# Comhairle Chontae Atha Cliath Theas

## Record of Executive Business and Chief Executive's Order

**Reg. Reference:** SD22A/0066      **Application Date:** 24-Feb-2022  
**Submission Type:** Additional      **Registration Date:** 07-Sep-2022  
Information

**Location:** 'Hillview', Dispensary Lane, Lucan, Co. Dublin, K78K2N1

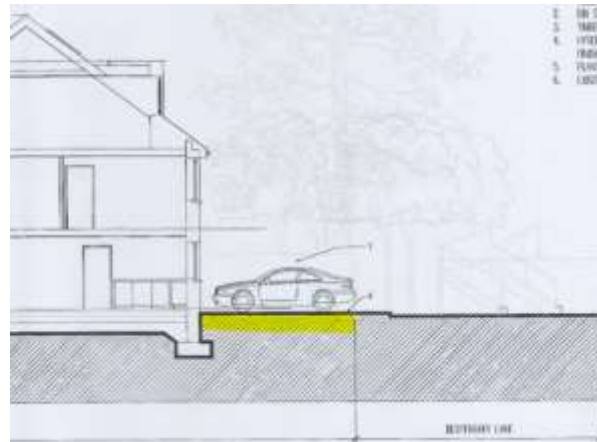
House Type	Total floor area (110sq.m min)*	Room	Floor Area provided	Floor Area Required	Min room width	Room width provided	Aggregate area required	Aggregate area provided
House 1 – 3bed	131.5sq.m	Kitchen	18.3sq.m	-	-	-	37sq.m	37.6sq.m
		Living	19.3sq.m	15sq.m	3.8m	3.9m		
		Bed1	12.9sq.m	11.4sq.m	2.8m	3m	36sq.m	53.8sq.m
		Bed2	13.5sq.m	11.4sq.m	2.8m	3m		
		Bed3	27.4sq.m	13sq.m	2.8m	2.4m		
		Store	7.89sq.m	6sq.m	-	-	-	-
House 2 – 3bed	131.5sq.m	Kitchen	18.3sq.m	-	-	-	37sq.m	37.6sq.m
		Living	19.3sq.m	15sq.m	3.8m	3.9m		
		Bed1	12.9sq.m	11.4sq.m	2.8m	3m	36sq.m	53.8sq.m
		Bed2	13.5sq.m	11.4sq.m	2.8m	3m		
		Bed3	27.4sq.m	13sq.m	2.8m	2.4m		
		Store	7.89sq.m	6sq.m	-	-	-	-
House 3 – 3bed	131.5sq.m	Kitchen	18.3sq.m	-	-	-	37sq.m	37.6sq.m
		Living	19.3sq.m	15sq.m	3.8m	3.9m		
		Bed1	12.9sq.m	11.4sq.m	2.8m	3m	36sq.m	53.8sq.m
		Bed2	13.5sq.m	11.4sq.m	2.8m	3m		
		Bed3	27.4sq.m	13sq.m	2.8m	2.4m		
		Store	7.89sq.m	6sq.m	-	-	-	-

The proposal is generally in keeping with the required standards; however, it is noted that the proposed master bedroom width is non-compliant in instances. The applicant is requested to address the bedroom width via **additional information**.
